MEMORANDUM

Our Ref: ENV/DC/PP/2015/0812

Location: O. S Grid Ref: 330 513 Land North of Total Fitness Ltd, Stansty Road, Wrexham.
Development: Residential Development (24 no. dwellings) together with highways, access and parking arrangements.

I refer to the email dated 09/12/2015 including revised site layout plan (Drg. No. 15.5554/1 Rev A) and Roads & Levels Plan (Drg. No. 15.5554/D1 Rev A) in respect of the above.

PARKING AND DRIVEWAY ARRANGEMENTS

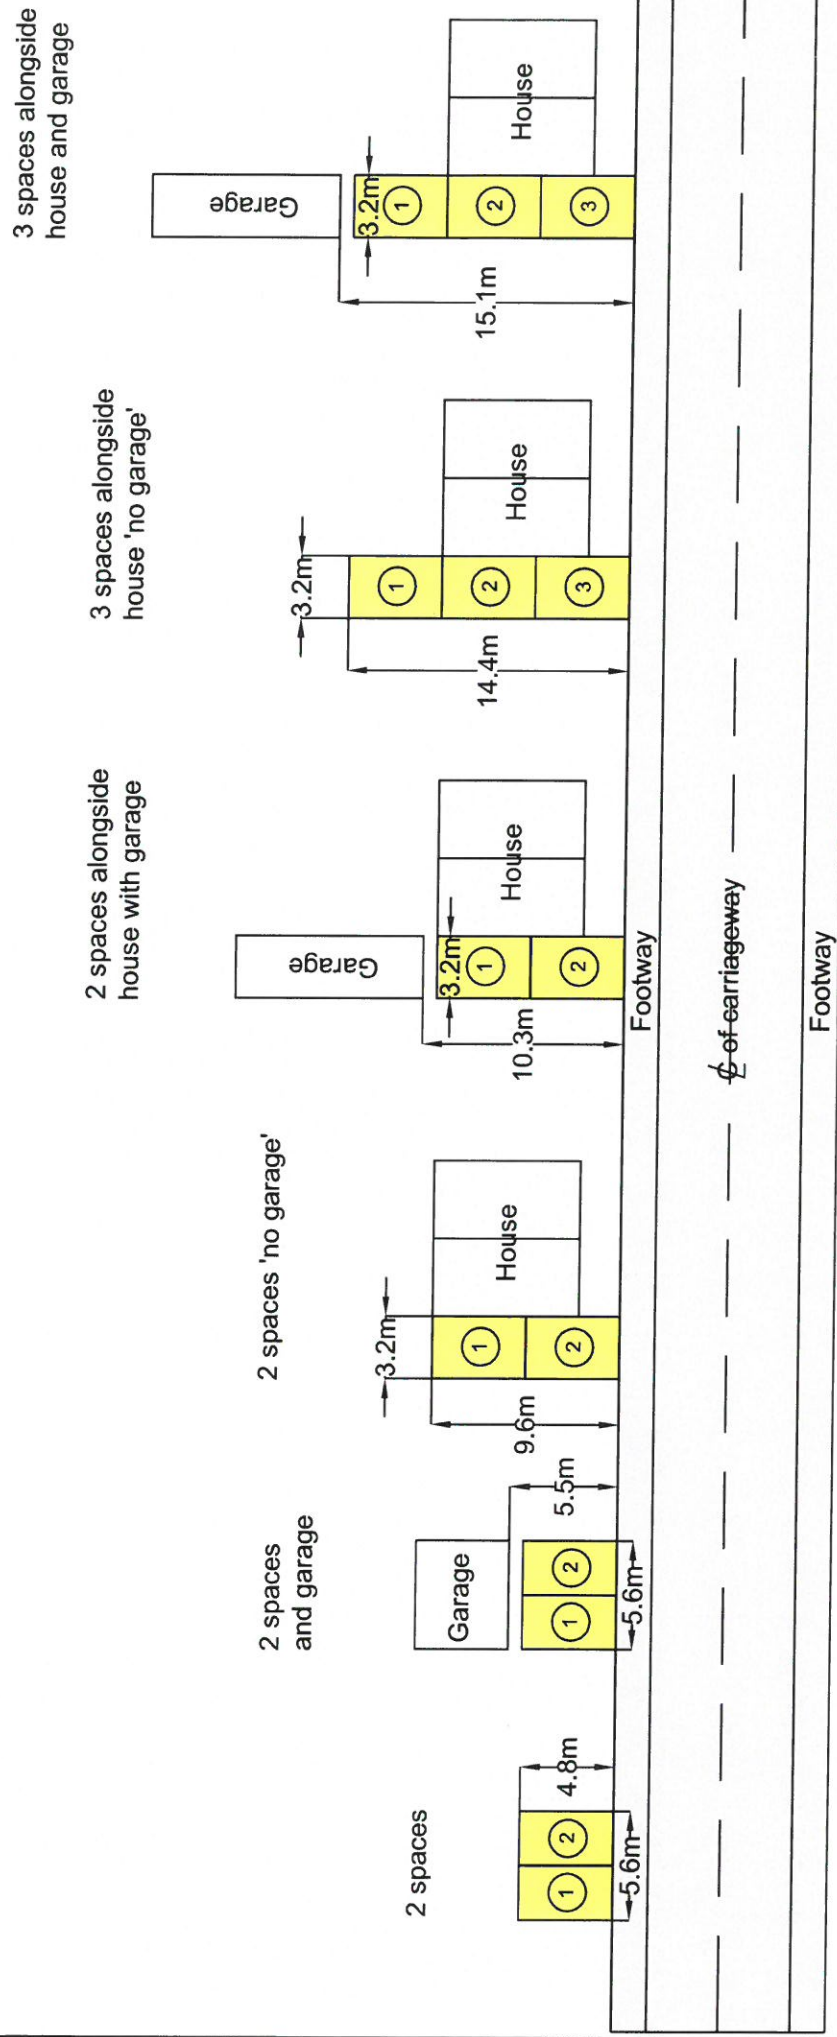
However, a number of the proposed driveways are of insufficient length and width. **I would recommend that the applicant amends / annotates the proposed driveway dimensions on a revised layout plan (see attached detail).**

7.5t Panel Van
 Overall Length
 Overall Width
 Overall Body Height
 Min Body Ground Clearance
 Track Width
 Lock to Lock Time
 Kerb to Kerb Turning Radius

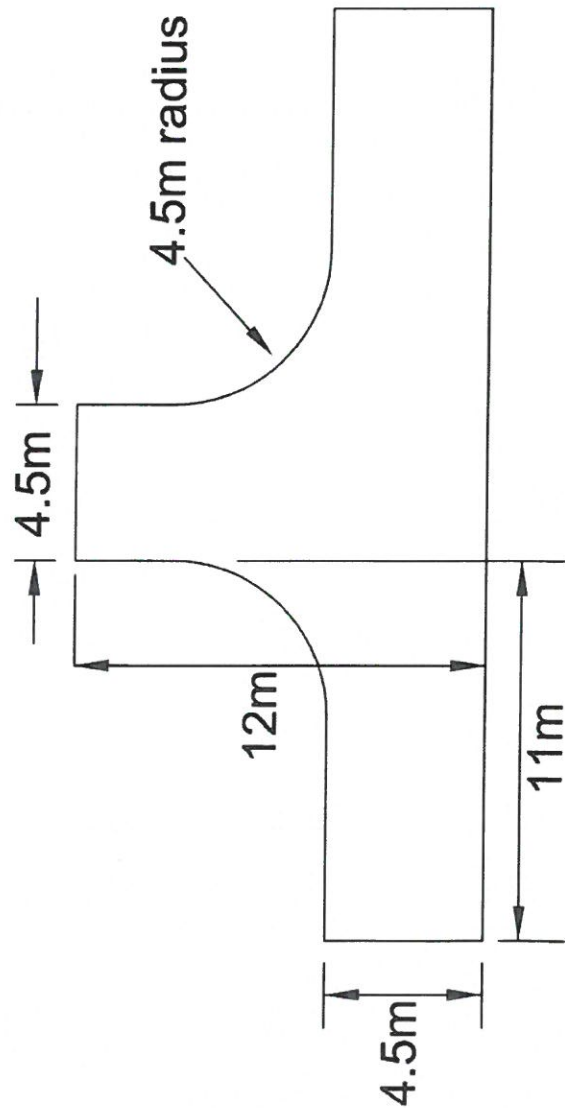
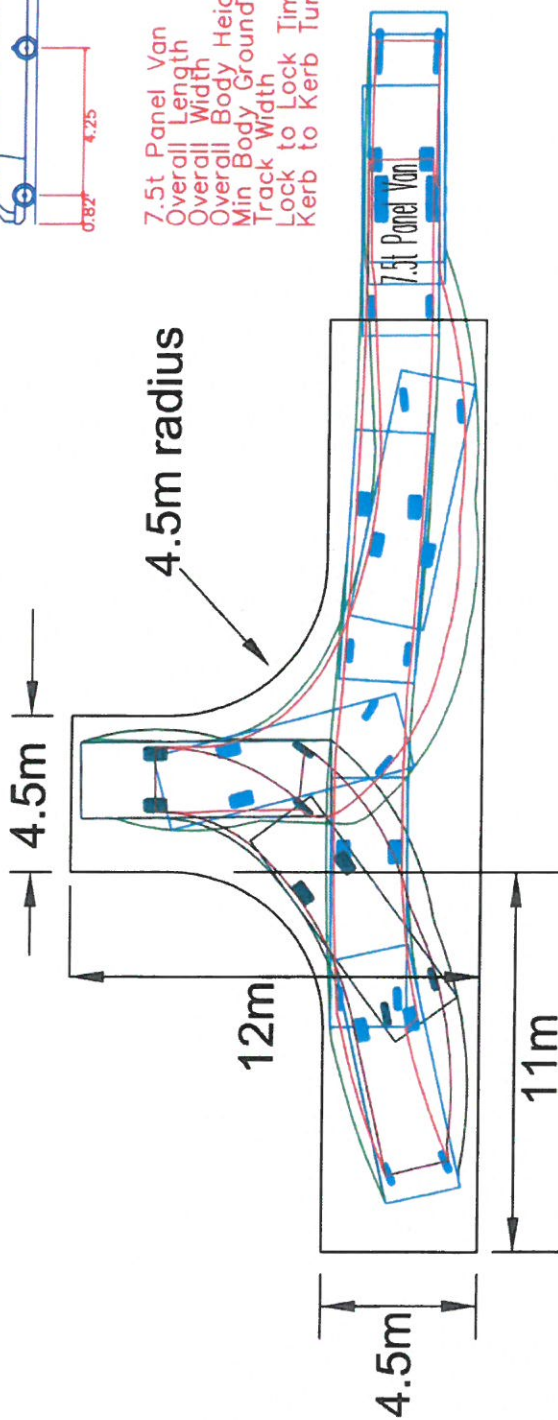
The private driveway serving plot nos. 1 – 6 has no turning head. **I would recommend that this driveway is provided with a suitable turning head to accommodate the turning movements of a medium sized HGV (see attached detail).**

Turning Areas

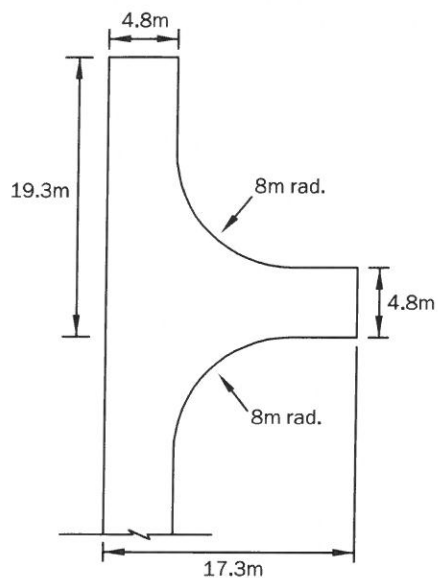
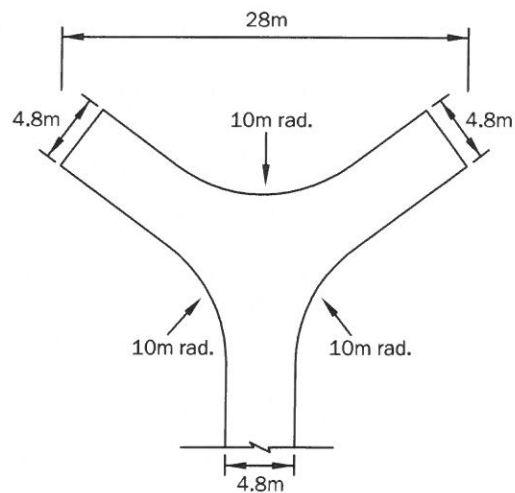
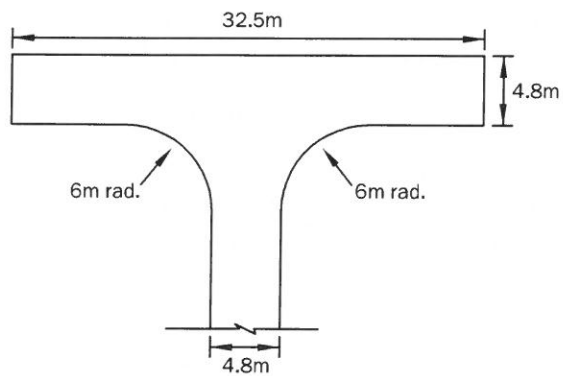
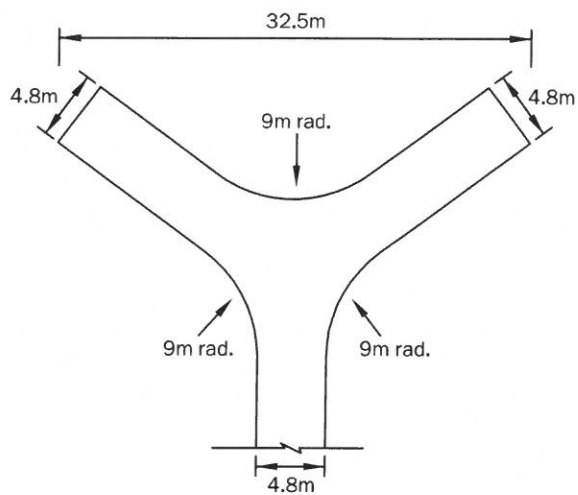
The proposed turning head fronting plot nos. 19 & 20 is inadequate and does not meet our current standards. **I would recommend that the applicant incorporates a turning head meeting our current standards (see attached detail).**

The parking provision for plot nos. 13 – 17 appears quite tight. The proposed layout will need to be re-configured in order to provide a suitably sized turning head (see attached detail). **I would recommend that the applicant amends the proposed turning head and parking provision in this location.**

Turning areas are based on an 11.18m long, 2.55m wide refuse vehicle.
